STATE OF CONNECTICUT  
CONNECTICUT SITING COUNCIL

IN RE: :  
 :  
 APPLICATION OF CELLCO PARTNERSHIP : DOCKET NO. 471  
 D/B/A VERIZON WIRELESS FOR A :  
 CERTIFICATE OF ENVIRONMENTAL :  
 COMPATIBILITY AND PUBLIC NEED FOR :  
 THE CONSTRUCTION, MAINTENANCE :  
 AND OPERATION OF A WIRELESS :  
 TELECOMMUNICATIONS FACILITY AT :  
 208 KIRK ROAD (a/k/a 1075 PARADISE :  
 AVENUE) IN HAMDEN, CONNECTICUT : MAY 23, 2017

**RESPONSES OF CELLCO PARTNERSHIP D/B/A VERIZON WIRELESS  
TO CONNECTICUT SITING COUNCIL PRE-HEARING QUESTIONS – SET 2**

SHEET NUMBER:  
**C-2**

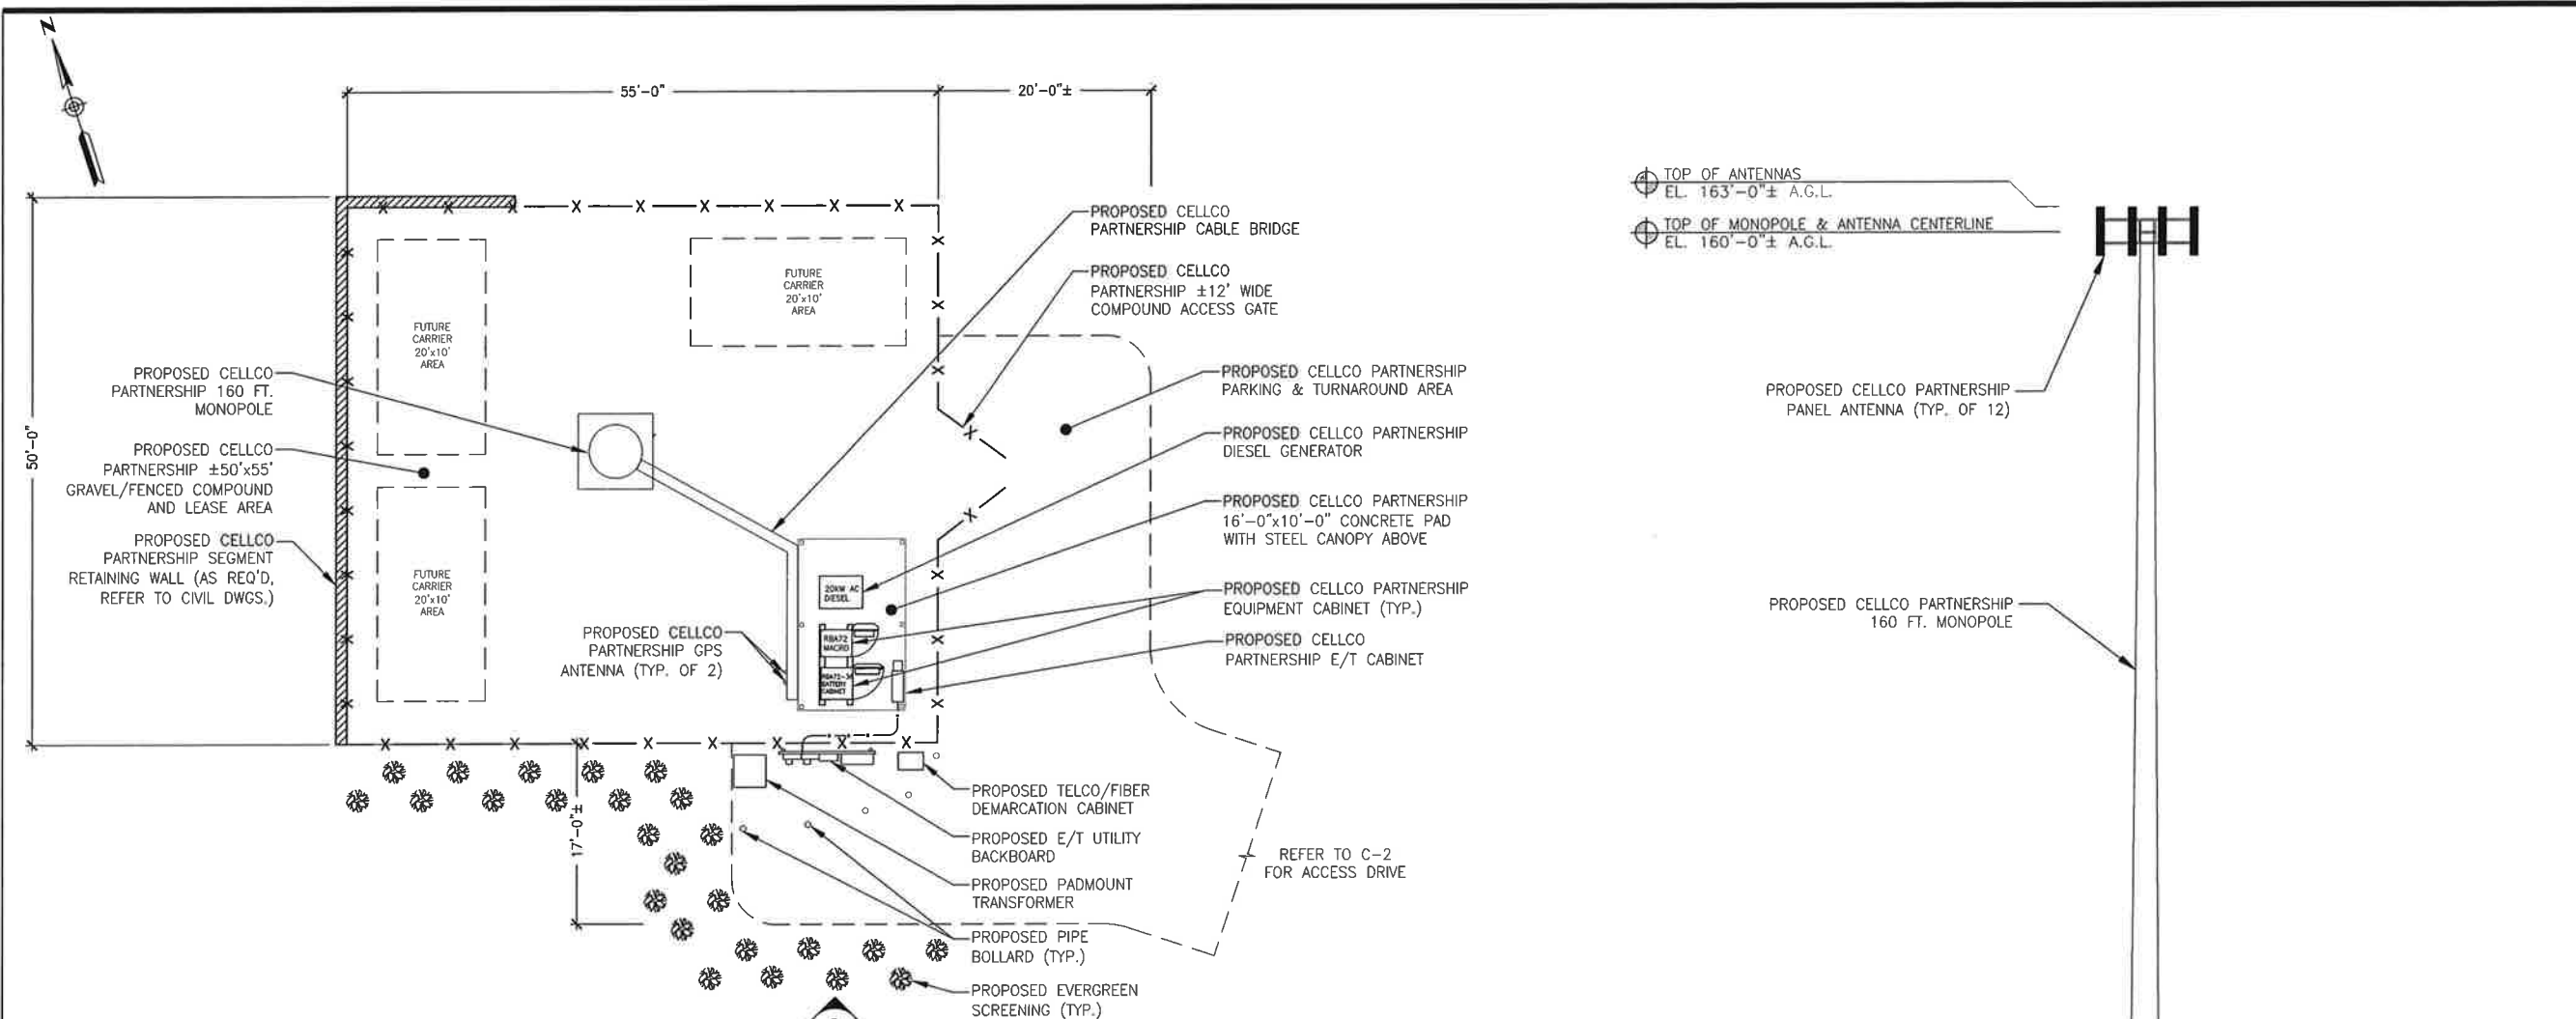
As discussed at the May 2, 2017 hearing (Tr. 1, pp. 21, 24-25), would the landlord be amenable to the following:

- a. Shifting the proposed parking area to the east side of the compound?
- b. Shifting the compound in a northerly direction?
- c. Shifting the proposed preferred access road slightly north to avoid removing shrubs and several large trees?

If so, please provide a revised site plan to account for these changes. Include revised distances of the compound fence to the Sorrentino home and property line.

Cellco's landlord would be amenable to the compound modifications described above including the shifting of the parking area to the east side of the facility compound; maintaining the tower location while the shifting of the compound in a northerly direction; and the shifting of the preferred access road to the north to avoid the removal of any additional large trees in the area. A revised site plan showing these modifications is included in Attachment 1 to these responses. This plan includes revised distances between the tower, facility compound improvements, and the access drive to the Sorrentino home and property line to the south.

SHEET NUMBER:  
**C-4**

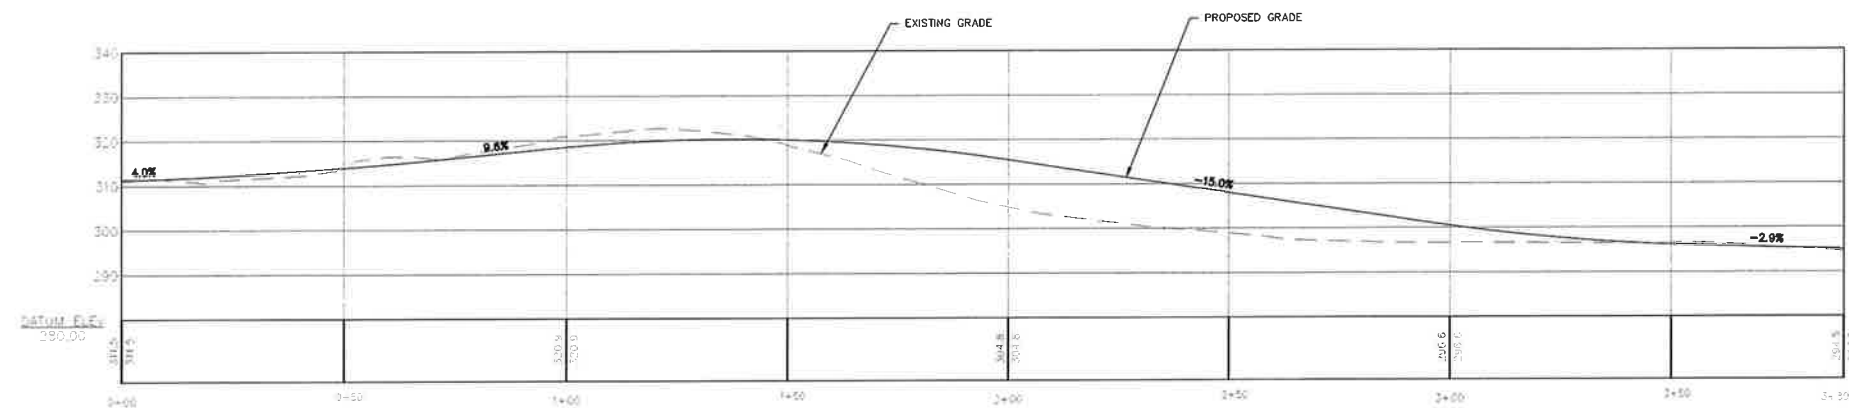
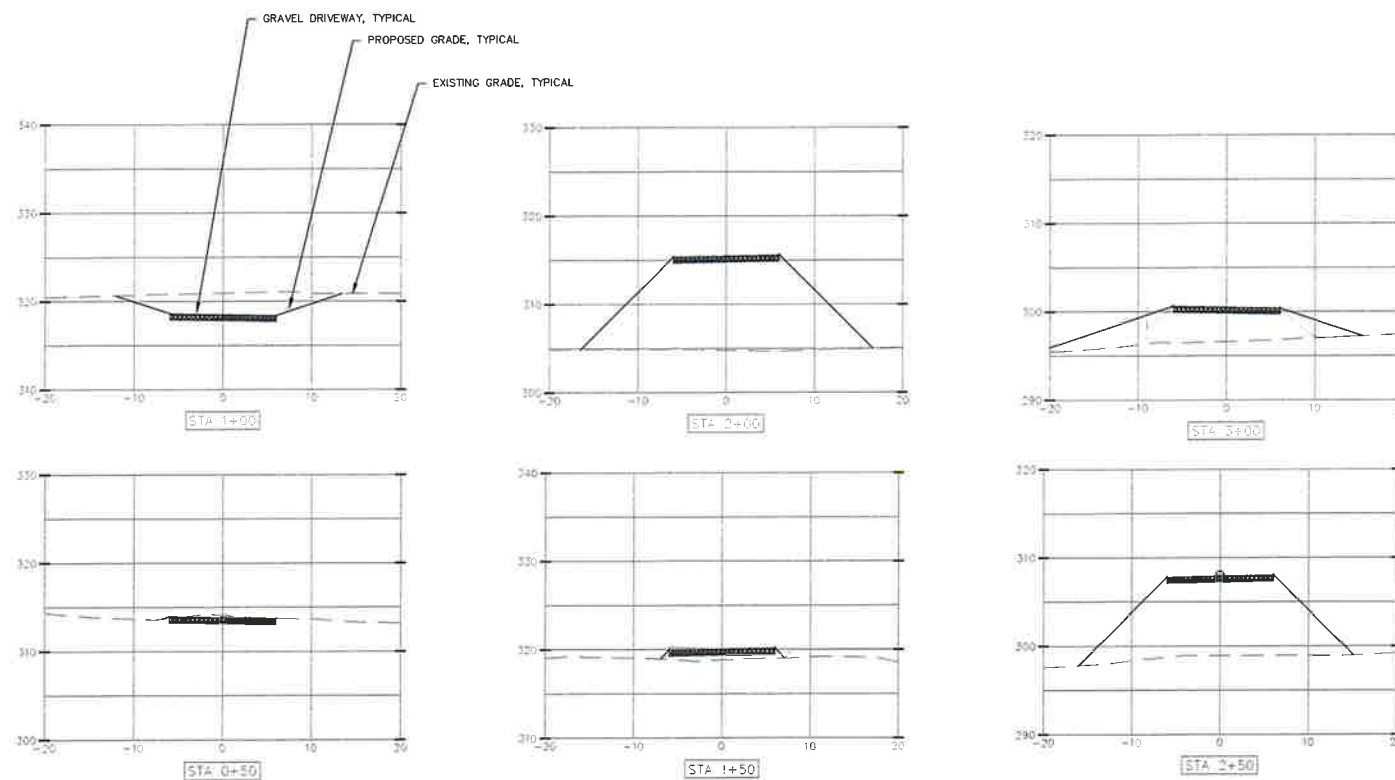
As discussed at the May 2, 2017 hearing (Tr. 1, pp. 85-87), provide a site plan for the preferred road alignment that includes stormwater controls (swales, level spreaders, silt barriers). Provide details of any proposed drainage swales along the new road alignment and how the

discharge of collected stormwater would impact the site and abutting properties. Provide a cross section and profile of the preferred road alignment.

Preliminary storm water controls for each of the alternative access driveway locations and tower sites provided on the site plans included in Attachments 1, 4 and 5.

**1 FENCE SECTION**  
C-8 Scale: N.T.S.

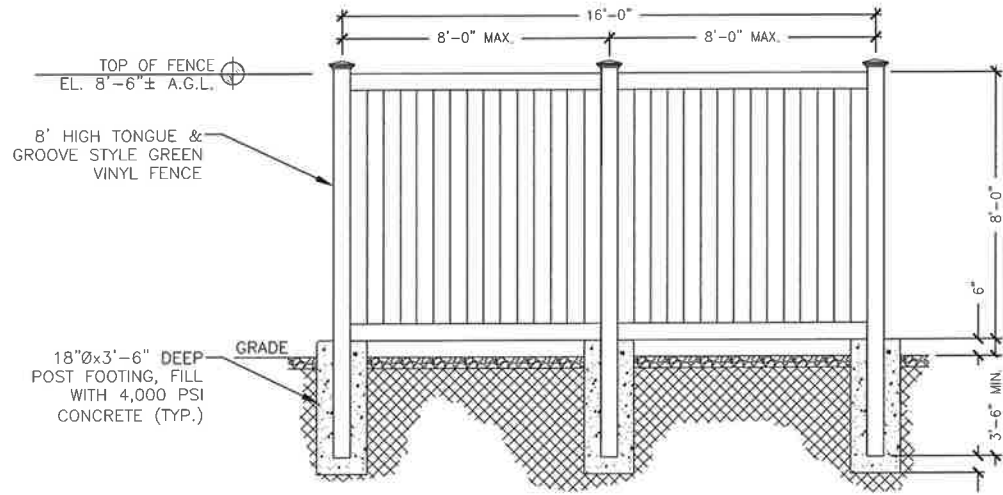
As discussed at the May 2, 2017 hearing (Tr. 1, pp. 42-50), provide a preliminary compound screening plan using fence treatments and/or landscaping.

After further consideration of fencing and screening options, Cellco has determined that the most effective way to screen equipment in the compound would be through the use of a solid, darker color (green or brown) stockade-type fence. Cellco would not object to the installation of landscaping around the outside of the fenced compound if additional screening is necessary. This approach also allows Cellco to maintain the entire compound area for the installation of equipment by additional wireless carriers. Details for the stockade fence are included on plan sheet C-8 in Attachment 1.

# **ATTACHMENT 2**

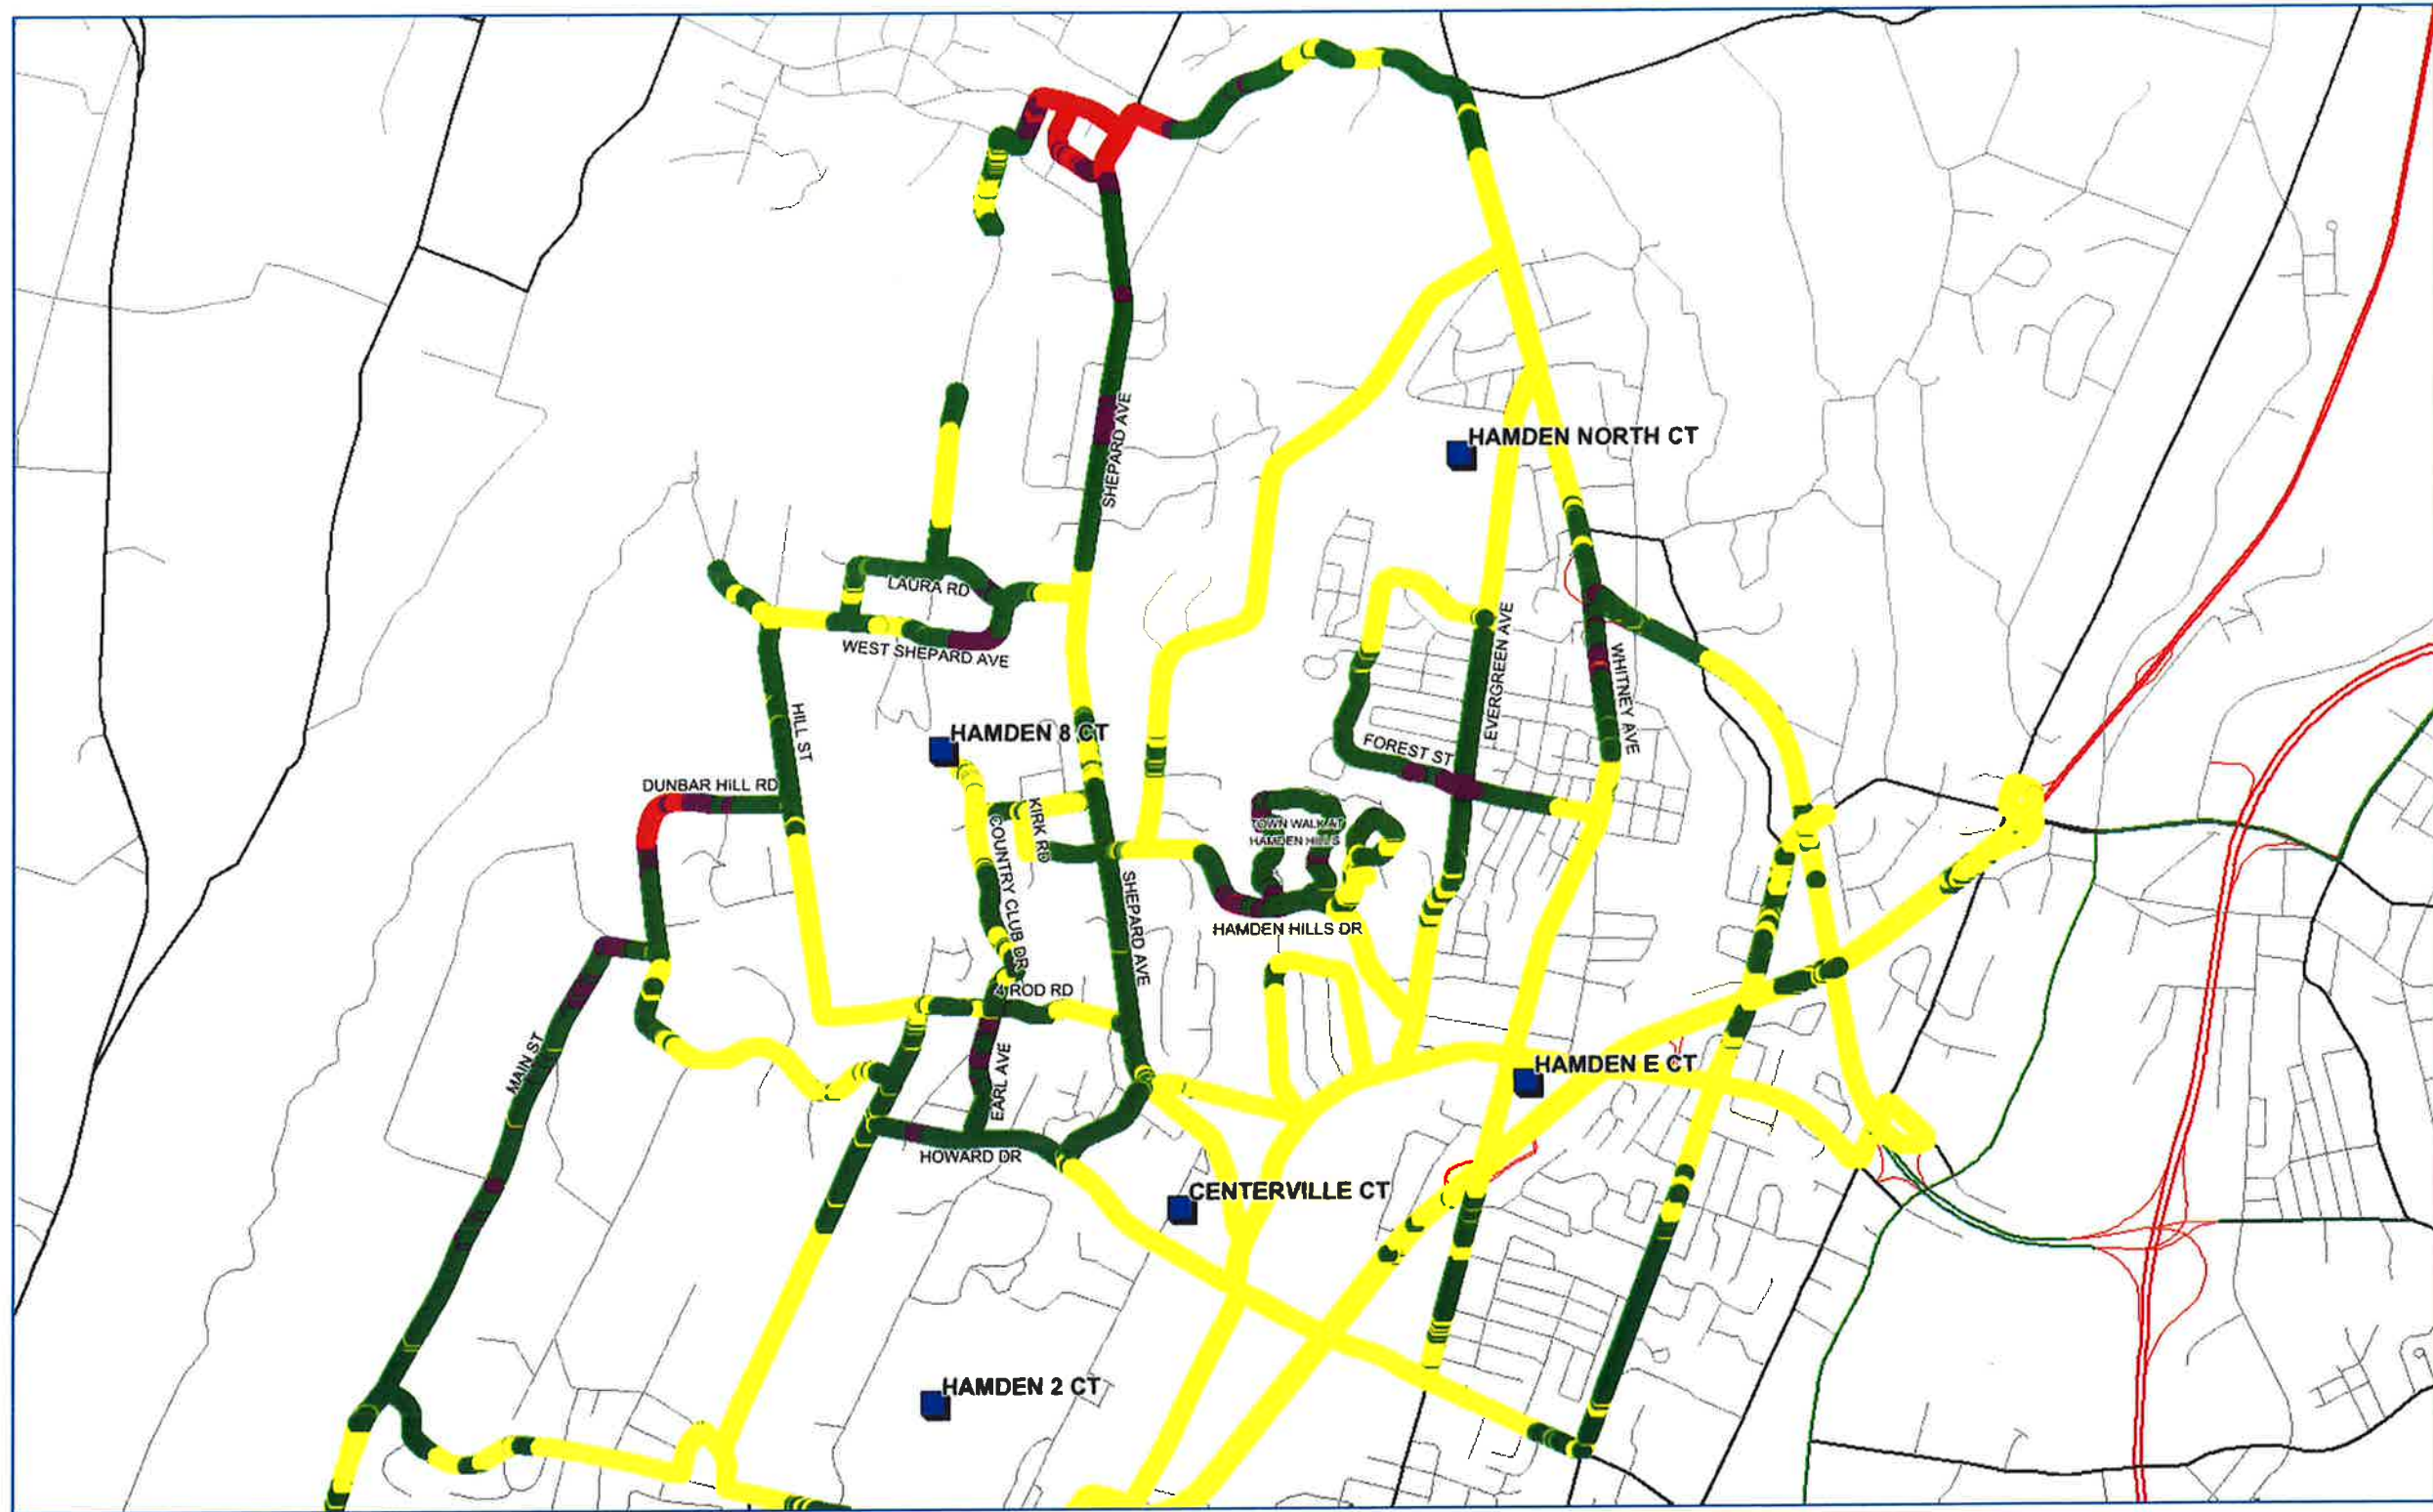
As discussed at the May 2, 2017 hearing (Tr. 1, pp. 51-52), provide a photo-simulation of the compound area from the abutting residential property lines to the south (46 & 50 Country Club Drive).

A photograph taken from the approximate location of the Sorrentino property line to the south is provided in Attachment 2. The silhouette outline of the proposed (revised) compound layout has been superimposed on the image to provide a representation of the position, distance and scale of the facility from this location.
